Access Compliance Report Public Rights-of-Way (Curb Ramps)

Main Street: MONTECITO_RD Cross Street: OAK_KNOLL_DR Location: SW

ADA ID: RPRK211220112231 Ramp Type: Type 1 - Perpendicular Diagonal Initial Pass/Fail: Pass Overall Compliance: No Severity Score: 0

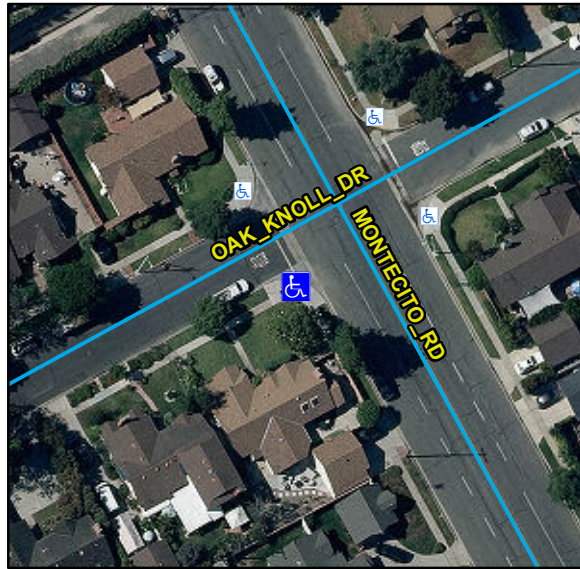
R304.2.2, R304.2.1, STD 1115

Remove & Replace Curb Ramp With Two New Directional Ramps or Equivalent.
